Truncation of London Gatwick SAM and KENET SIDs (ACP-2017-65) – Post Implementation Review

CAP 2134

Figure 1 – The SID Truncations

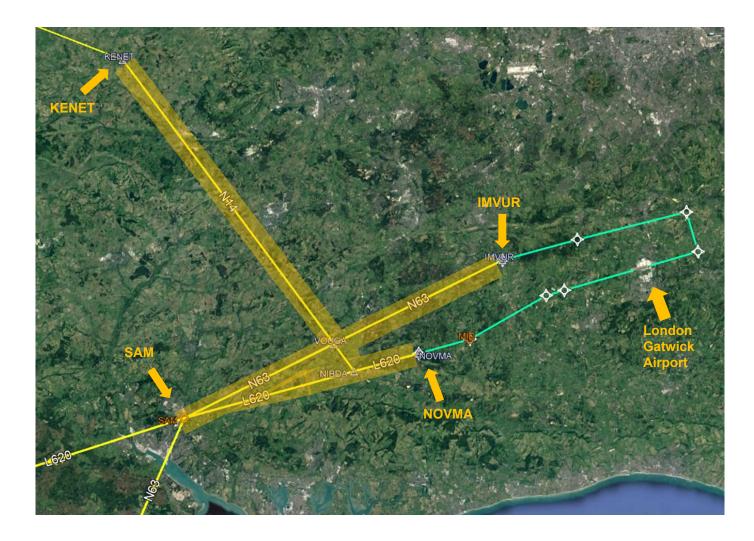
- 23. Figure 1 shows the current SIDs after truncation (green), the truncated sections of the previous SIDs (yellow with orange highlight) and the relevant parts of the main route network (yellow). Prior to the truncations, airlines would be expected to plan to fly all the way to SAM or KENET at a maximum of 4000ft, and to carry the necessary fuel accordingly. Following the truncations, airlines can plan to start climbing above 4000ft from IMVUR or NOVMA, taking the corresponding reduced fuel consumption into account.

- 25. The Sponsor reported that initially there was a degree of uncertainty/confusion about where aircraft should head once they had flown the truncated SID. In particular, this occurred when the wind, and thus runway, direction changed, as follows:

- While changing the aircraft navigation systems to fly an IMVUR SID rather than a NOVMA SID ensured the aircraft departed London Gatwick correctly, it would not change the list of expected subsequent points after the end of the SID. In some cases, the aircraft onboard navigation computers attempted to send the aircraft to NOVMA in the mistaken belief that this was the next relevant navigation point.

- 28. Airlines reported initial Flight Crew uncertainty and track deviation issues, as discussed under Safety.
- 29. Following the resolution of these through the production of revised planning and briefing materials (publication of a NOTAM, adding route information to the SID descriptions in the UK AIP, additional information added to some third party SID charts), no further issues have been raised.

45. The CAA is satisfied that, following the adoption of mitigation actions to improve clarity (publication of a NOTAM, adding route information to the SID descriptions in the UK AIP, additional information added to some third party SID charts), the truncation of the SAM and KENET SIDs to NOVMA and IMVUR has satisfactorily achieved the intended objectives, and the change is confirmed.
